REVIEW COMMENTS

FILE #PP-96-130

TITLE HEADING: Wilson Ranch Townhomes (Filing #5
of Wilson Ranch)

RE: G 1/2 Road - Wilson Ranch Townhomes

PRINCIPAL ARTERIAL

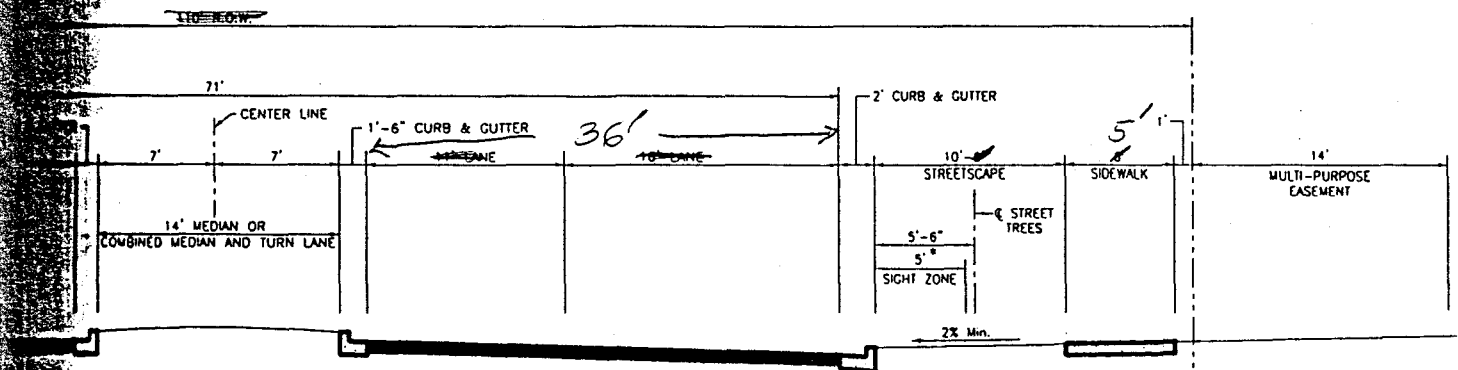
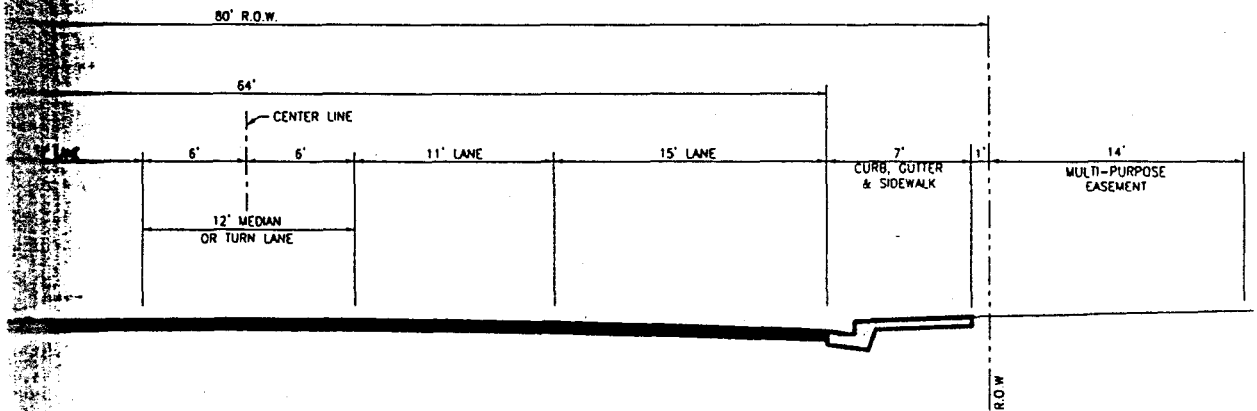
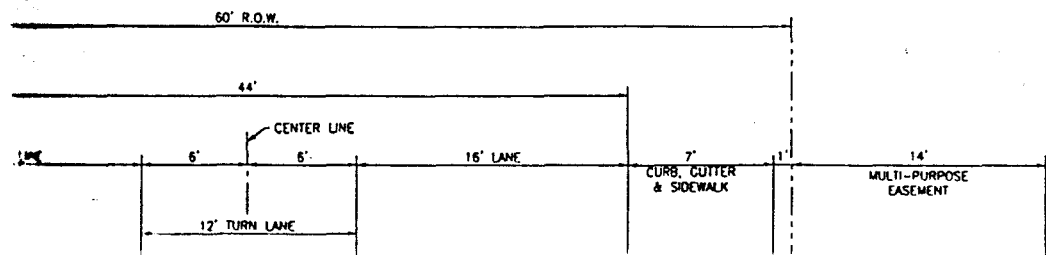
Public Works staff has reviewed your proposed roadway cross-section for G 1/2 Road in conjunction with the development of the Wilson Ranch Townhomes and offer the following comments.

As proposed, the cross-section does not conform with current City standards. Section 5-4-1(E) requires "streets, sidewalks, trails and bike paths shall be constructed in accordance with applicable City of Grand Junction standards." Any variation from city standards must be approved by City Council. Variances to section 5-4 of the code are covered in section 5-4-16 and require recommendation by Planning Commission to the City Council. There is a \$50 advertising fee along with a submission in writing of the request for variance and ten copies of the proposed cross-section. You may contact Kathy Portner in Community Development for submission dates.

Staff recommendation for pavement width is 36', which is the standard residential collector section. Any proposal for a narrower pavement must also be supported by evidence of existing, proposed and future traffic projections. The 36' wide pavement allows us to stripe bike lanes and provides adequate room for turning vehicles at intersections.

Public Works staff supports the concept of omitting sidewalk on the north side of G 1/2 Road adjacent to the I-70 right of way, and supports the detached walk on the south side.

City standards require curb and gutter. The curb serves as a barrier as well as delineation of the roadway edge. The flat gutter proposed does not prohibit vehicles from leaving the pavement edge and allows dirt, mud and debris onto the pavement. With the flat gutter, additional shoulder maintenance is required assure there are no drop-offs than is required with a standard curb.

The proposed 10 foot landscaped strip between the pavement and the detached walk is aesthetically pleasing and desirable. However, we have some concerns about the design and maintenance of this area. Based on his experience, the City Streets Superintendent has indicated the depressed area will become filled in with roadway debris such as dirt, rocks, and mud and the flowline will become difficult to maintain as the landscaping matures. This will cause

future drainage maintenance problems. Constructing curb and gutter will eliminate the buildup of debris in the landscaping and the need to try to maintain a flowline through the center of the landscaping. Staff recommendation is standard curb and gutter with landscaping slightly above the top of curb grade.

An acceptable alternative street section which would not require council approval is attached for your information. Basically, it is a modification of one half of the principal arterial street section with 36' of pavement width, curb and gutter and a detached walk.
